DRAFT DECISION: PROPOSED ACCESS ARRANGEMENT DAMPIER TO BUNBURY NATURAL GAS PIPELINE

Epic Energy (WA) Transmission Pty Ltd

**INDEPENDENT GAS PIPELINES ACCESS REGULATOR
WESTERN AUSTRALIA**

21 June 2001

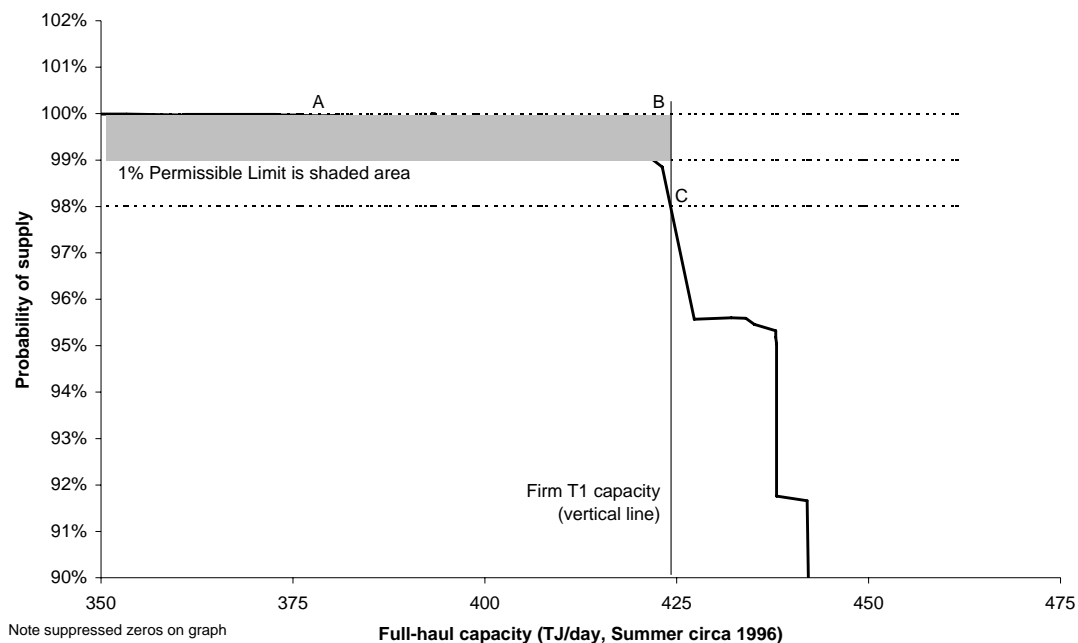
The graph [in Alintagas's Submission 3] shows the probability of supply for full-haul summer capacity on the DBNGP as the pipeline was configured around the summer of 1996. The data is from a report by Tenneco Energy International (now Epic Energy) in November 1996, titled "*A Study of the Dampier to Bunbury Natural Gas Pipeline*" (the "Tenneco Report"). The graph is a conservative one, since it shows the probability of supply without the implementation of recommendations in the Tenneco Report designed to improve the reliability of the DBNGP. AlintaGas does not have access to more up-to-date information.

The rectangular shaded area in the graph shows capacity that Epic Energy proposes may be curtailed as part of the one percent permissible limit. As the graph shows, a substantial portion of the capacity that may be curtailed can be expected to be available.

AlintaGas submits that the curtailment provisions proposed by Epic Energy are excessive and do not reflect the fair and reasonable reliability expectations for users of a "firm" service on the DBNGP. AlintaGas submits that having a one percent permissible limit will provide Epic Energy with the opportunity to sell more capacity as Firm Capacity. This can be seen from the above graph. As the vertical line is shifted to the right, more capacity becomes available, albeit capacity with a low probability of supply. Since the one percent permissible limit, as represented by the shaded area, is so generous, Epic Energy will be able to sell the less reliable capacity as firm capacity and Epic Energy will still be able to meet its contractual commitments.

Historical and Projected Non-Capital Costs (nominal \$million)¹⁹⁷

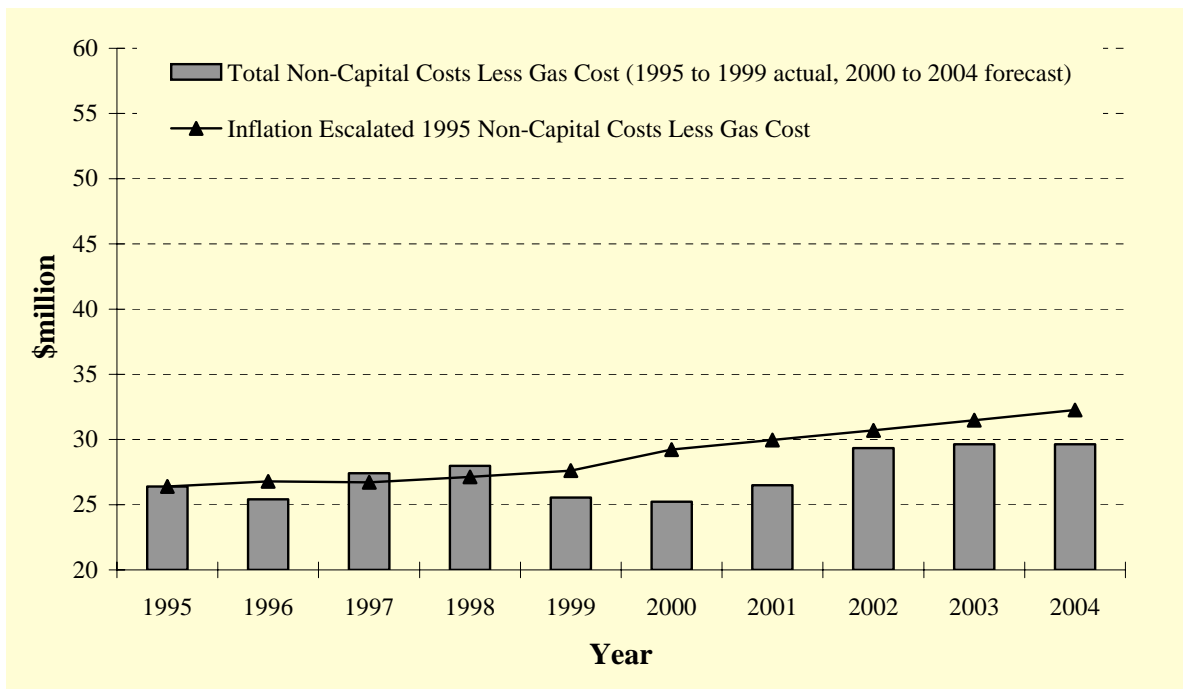
In undertaking the assessment, the Regulator noted that the forecasts of Non-Capital costs do not limit nor constrain Epic Energy as to the level or composition of Non-Capital Costs actually realised over the Access Arrangement Period. For this reason, the Regulator gave attention to both the total level of Non-Capital Costs that will be recognised in the derivation of the Reference tariff, and individual cost components.

Historical and Projected Contracted Capacity

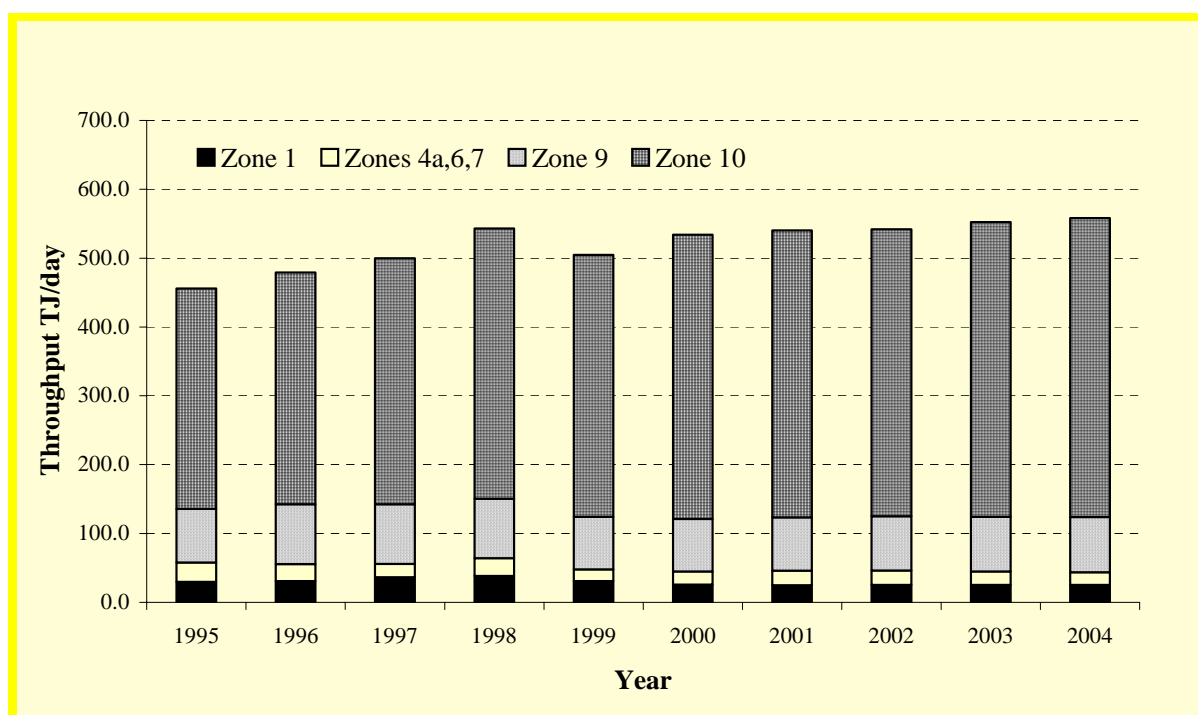
The Office of Energy has forecast increases in natural gas use in Western Australia of approximately eight percent per annum over the period 2000 to 2009 with a large part of these increases occurring in the approximate period 2003 to 2005. Part of this is attributable to projected increases in gas demand arising from major industrial projects that would be serviced by the DBNGP, including the Kingstream Steel project, the Mt Gibson Iron project and expansion of titanium dioxide processing operations at Kemerton. Further, the Office of Energy has forecast increases in domestic residential natural gas and electricity use over the period 2000 to 2009 by 2.2 percent and 2.4 percent per annum, respectively, although gas use for residential gas and electricity consumption would form a relatively minor part of total gas consumption.

AlintaGas has forecast an increase in gas throughput through its distribution systems of 3.8 TJ/day (5 percent) for the period 2000 to 2004, virtually all of which would be transported through the DBNGP. Epic Energy's forecast increase in throughput for the Access Arrangement Period is consistent with the AlintaGas forecast.

Historical and Projected Throughput Volumes

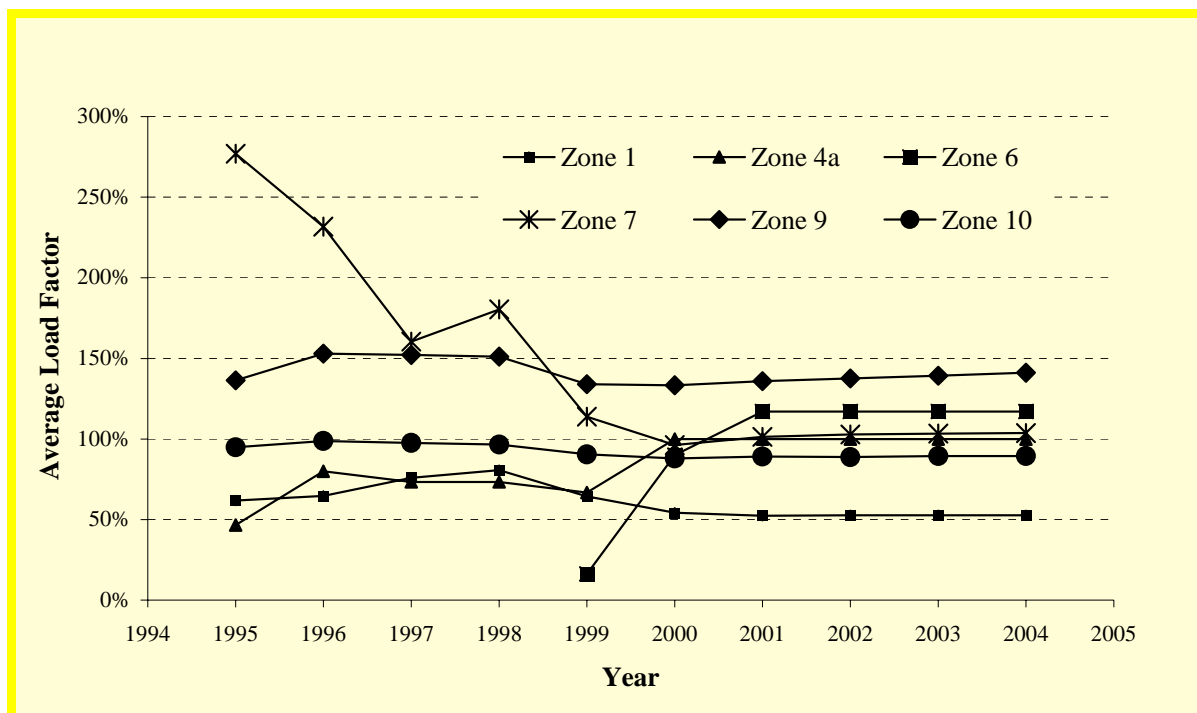
In considering Epic Energy's forecast of contracted capacity and throughput, the Regulator has given attention to:
